January 9, 2015
10 CFR 50.90
SBK-L-14225
Docket No. 50-443

Seabrook Station
Response to Request for Additional Information Regarding License Amendment Request 14-02
Proposed Change to Increase Voltage Limit for Diesel Generator Load Rejection Surveillance Requirement

**Response to NRC RAIs Regarding
License Amendment Request 14-02
Proposed Change to Increase Voltage Limit for Diesel Generator Load Rejection
Surveillance Requirement**

DIESEL GENERATOR DG-1A AND DG-1B ONE LINE DIAGRAM
SHEET 1 OF 2
UNIT 1 1-NHY- 310010

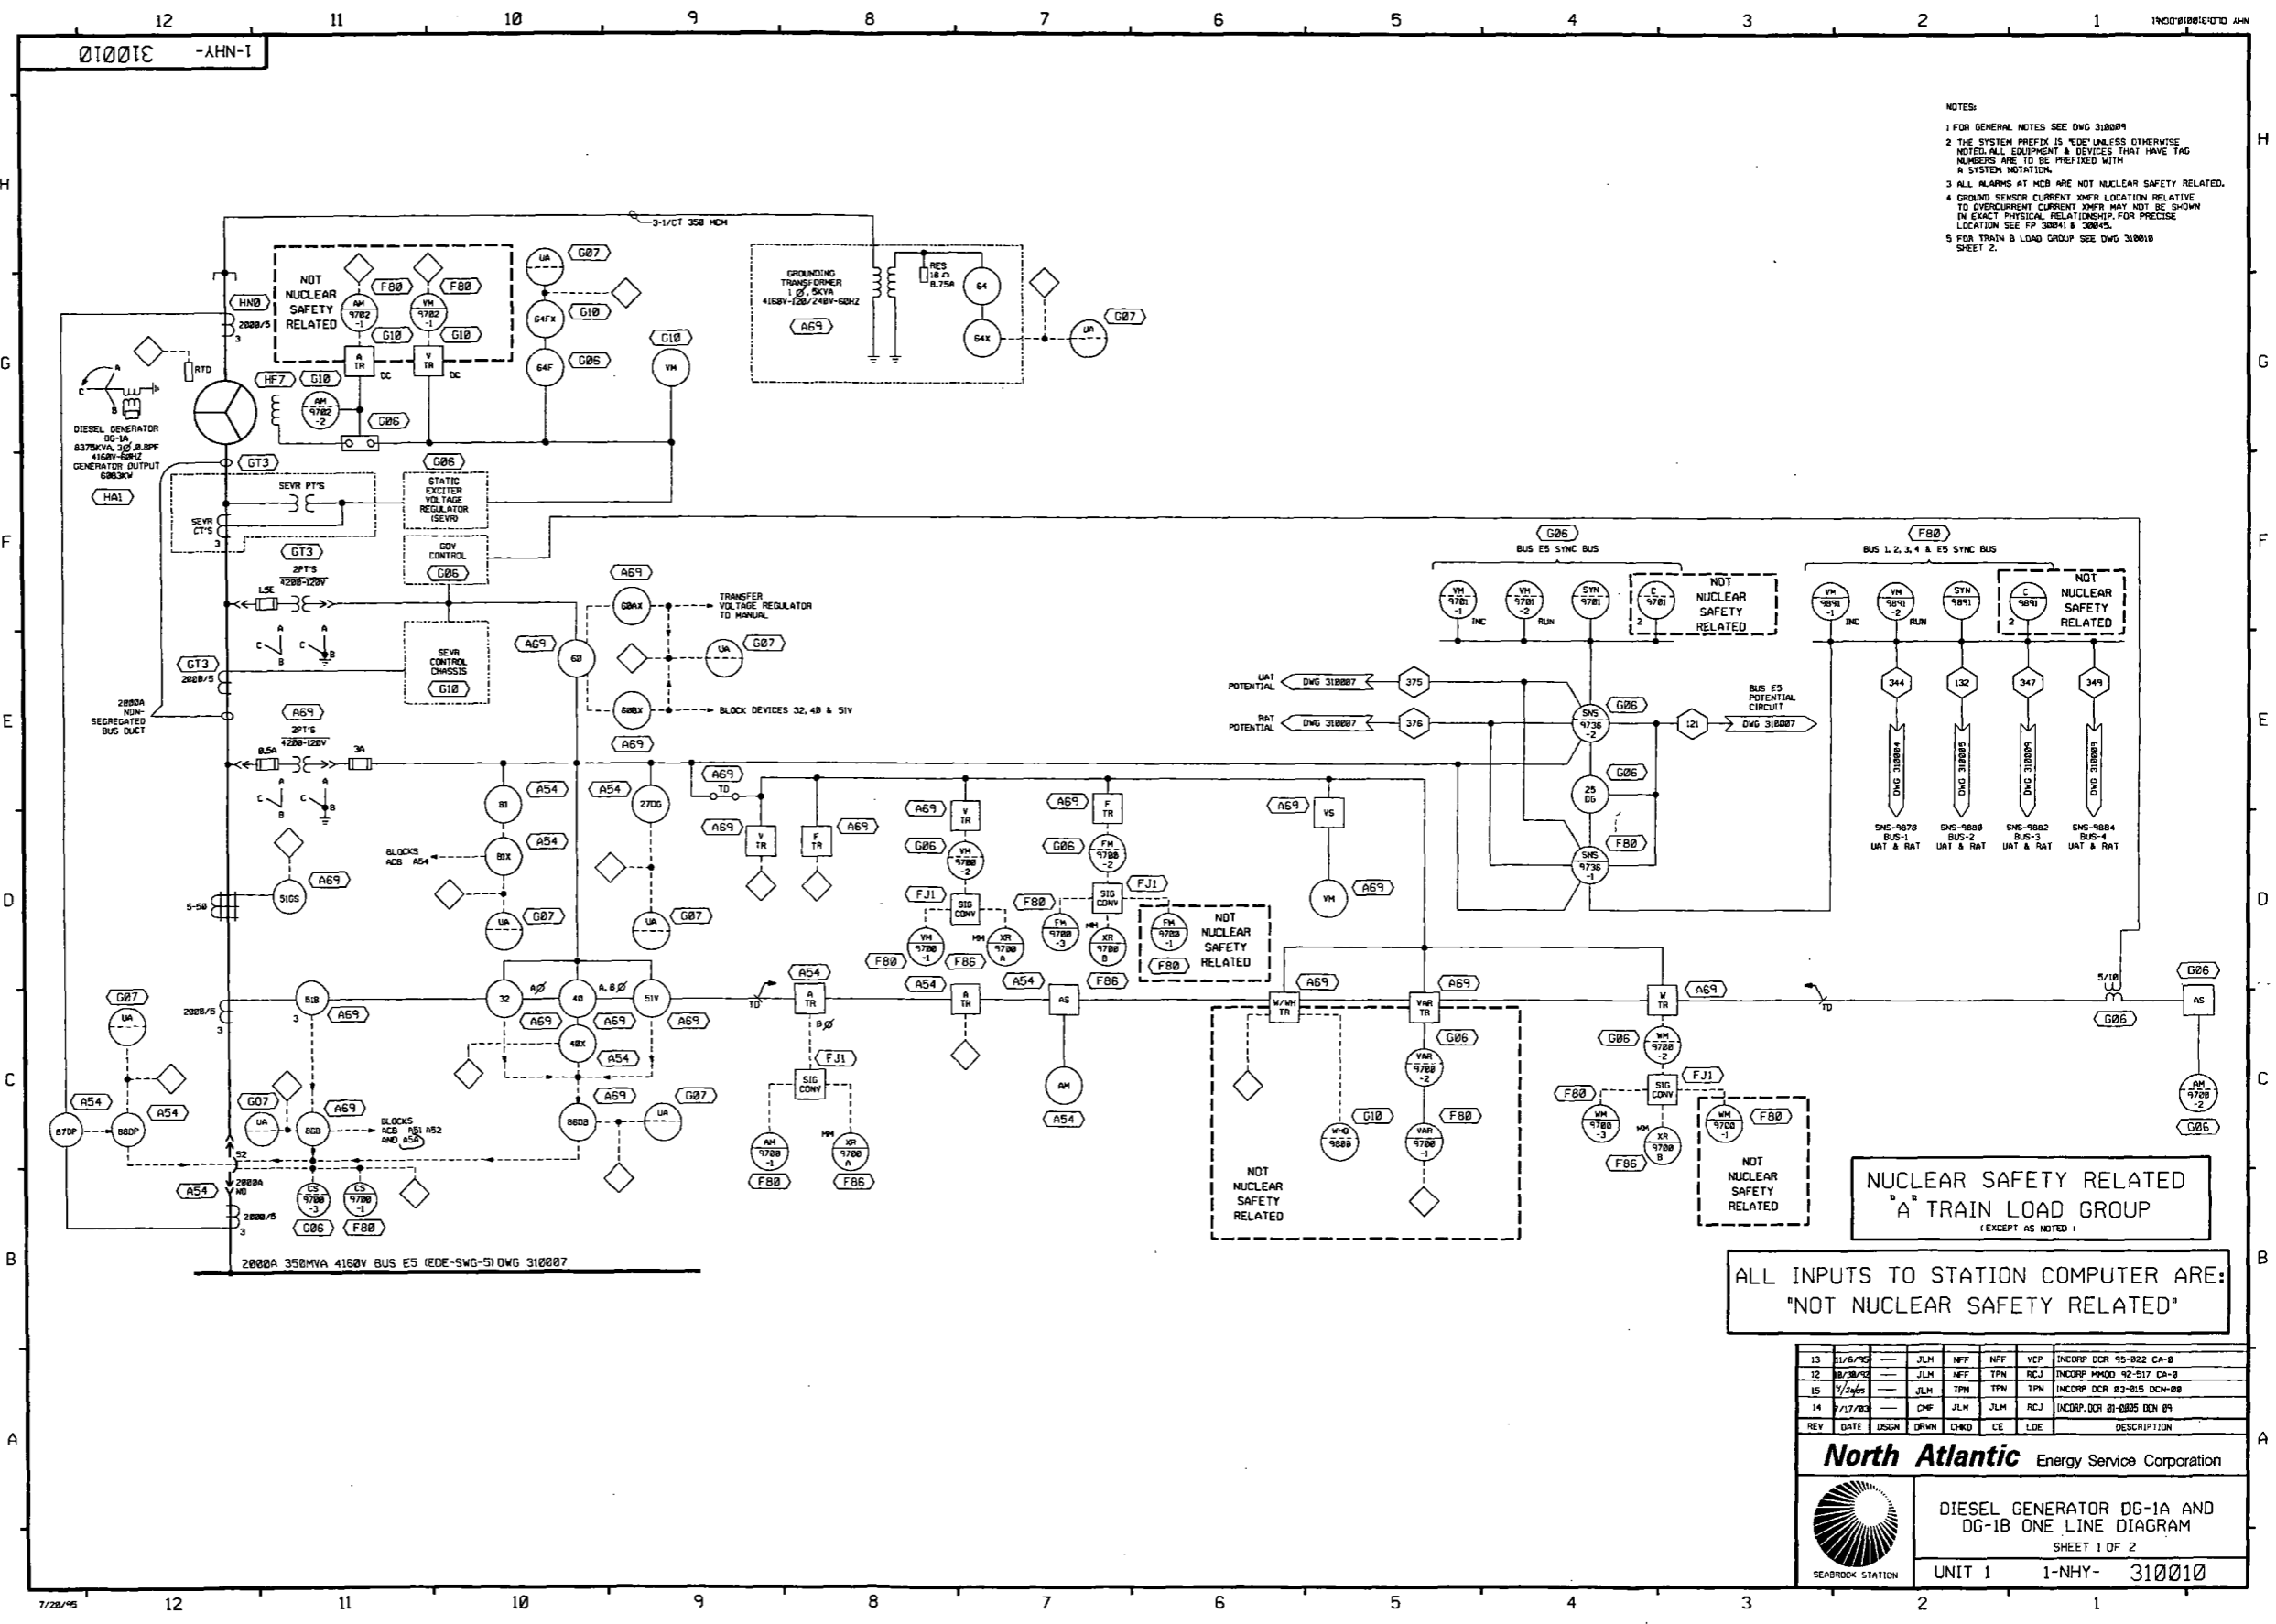
Please provide a copy of the single line diagram showing the connection of one of the EDGs to an emergency bus and associated protections (protective relays, etc.) provided for the EDG.

See Attachment 2 for drawing 1-NHY-310010, Sh. 1, Diesel Generator DG-1A and DG-1B One Line Diagram, for DG-1A protective relays.
